CITY OF OPELIKA HISTORIC PRESERVATION COMMISSION

October 10, 2024

City of Opelika
Historic Preservation Commission
Staff Report

Agenda Item #: 1
Meeting Date: 10/10/2024
Action Requested: COA: Enclose Rear Screen Porch; Add Screen Porch on Front
Location of Property: 1000 3rd Ave; Northside Historic District
Petitioner: Delmar Hammonds

Proposed rear addition w/new door and walkway relocation; side of front porch screen enclosure

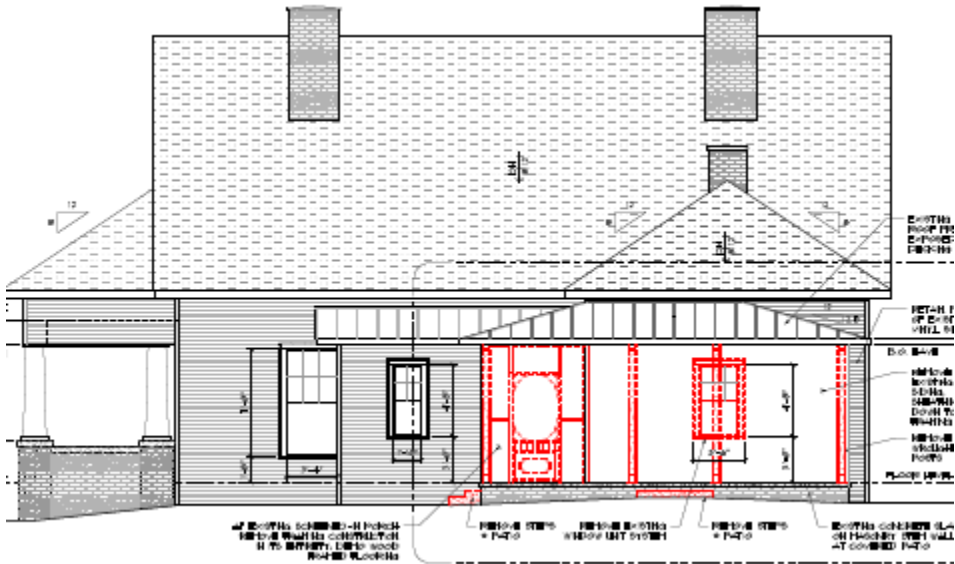
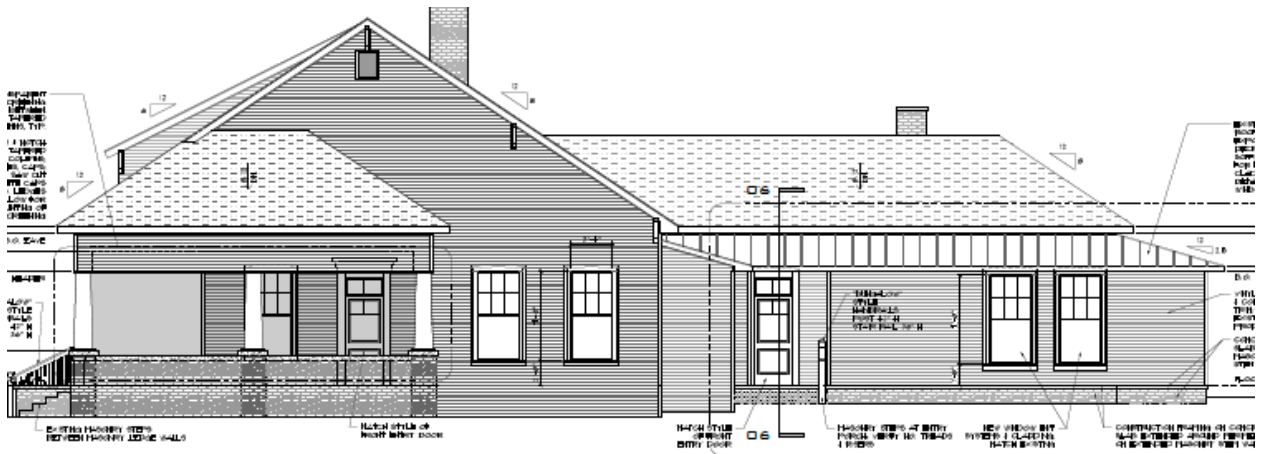
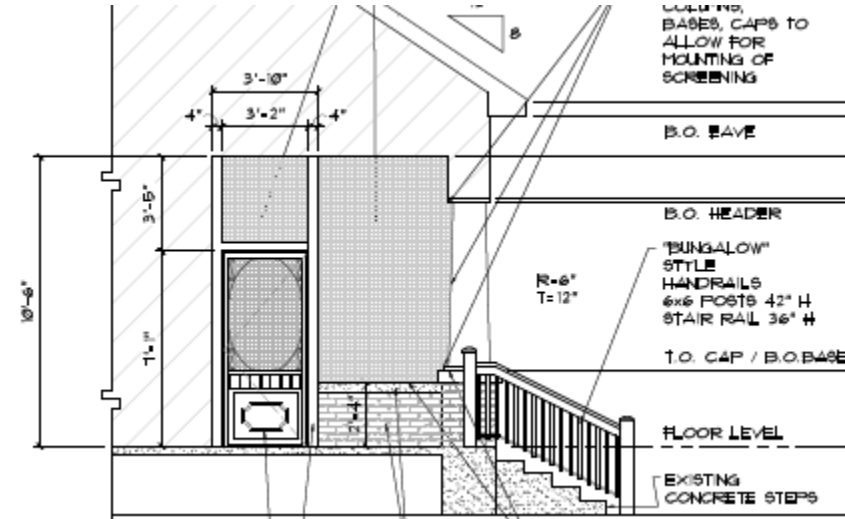
1. Demo rear screened porch w/decking and rebuild same footprint of screened area and rear covered porch on concrete slab with masonry stem wall to accommodate a walk-in closet and bathroom in master bedroom. All vinyl will be saved and reused on addition. New wood exterior door and (4) composite windows to be installed. Windows are double hung with wood sash, SDL 6/1- 7/8" wood bars, with PVC brick mold. Style to match existing windows. Roof will be metal.

2. Remove window on right side porch and replace with wood door to allow access onto porch. Enclose right side of front porch with transparent screening between existing columns.

3. Install handrails at front entrance of either wood or wrought iron.
4. Relocate side walkway from the city sidewalk to new exterior rear steps and landing. Bungalow style handrails will be wood and painted white. Second option would be to use wrought iron handrail.

1. Staff recommends approval of demolition of rear screen porch and construction of addition with same footprint as screen porch and covered rear porch. Existing vinyl siding to be used.
2. Staff recommends approval of wood doors and Tucker composite windows matching existing doors and windows.
3. Staff recommends approval of replacing side window with door.
4. Staff recommends the Commission consider allowing the screening of the front porch only if you feel it does not compromise or destroy the intended appearance of the original design as outlined in the guidelines.
5. Staff recommends approval of painted wood handrails and relocation of concrete walkway.

Revised site plan

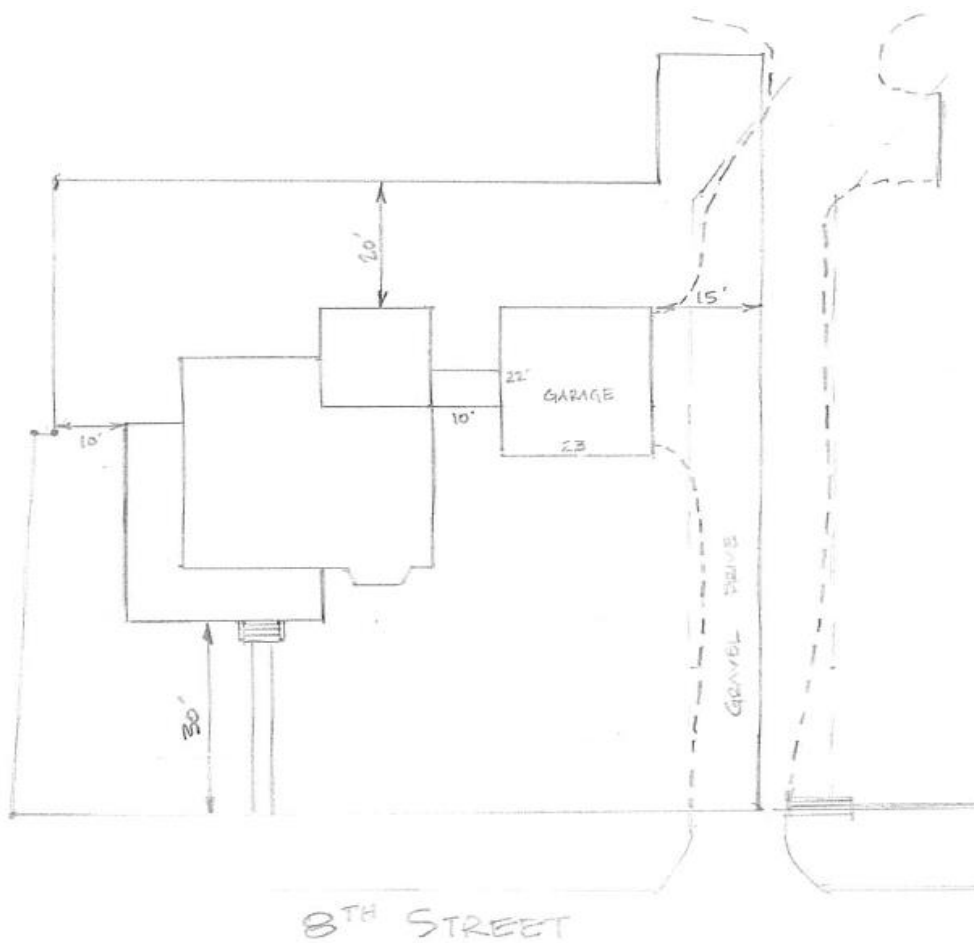
History: The applicant received COA approval on 4/11/24 for new construction home with detached open carport. It was discovered that the shared drive intersected with the garage. On 08/08/24 approval was granted to shift drive to the right and remove part of rock retaining wall.

1. Staff recommends approval of side entry two car garage of horizontal lap siding with breezeway connecting to house.
2. Setbacks to be approved by the Planning Department.

Site plan

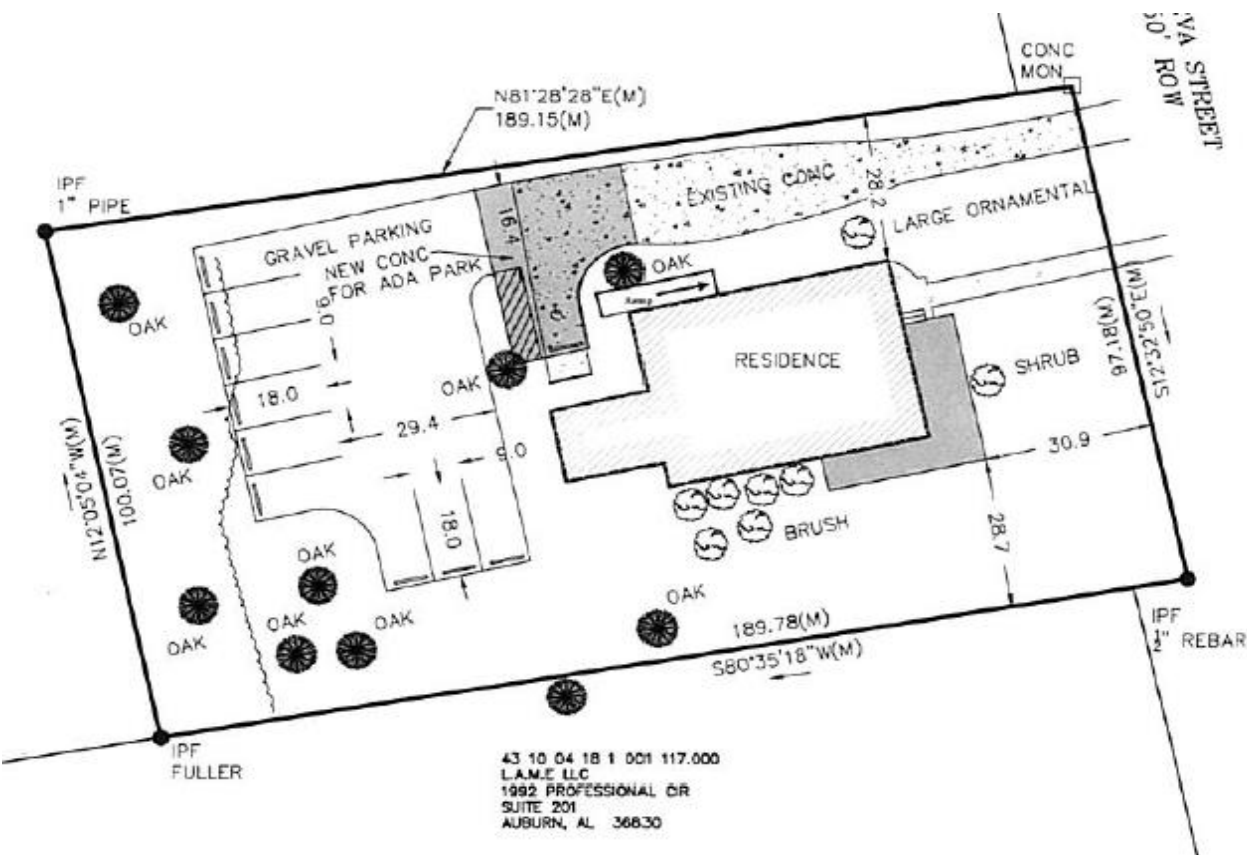
1. A gravel parking area will be located in the rear and contain approximately eight (8) spaces.
2. Add one (1) concrete parking spot with wheelchair accessible ramp. Ramp will be constructed with wood decking and railing. Small bushes to be planted to block visibility of handicap parking from road.

1. *Staff recommends approval of gravel parking area, located in C-2 zone contingent on use and zoning approval by Planning Department.*
2. *Staff recommends some buffering between properties to block view of parking and a landscape plan which meets or exceeds the requirements of the Zoning Ordinance.*
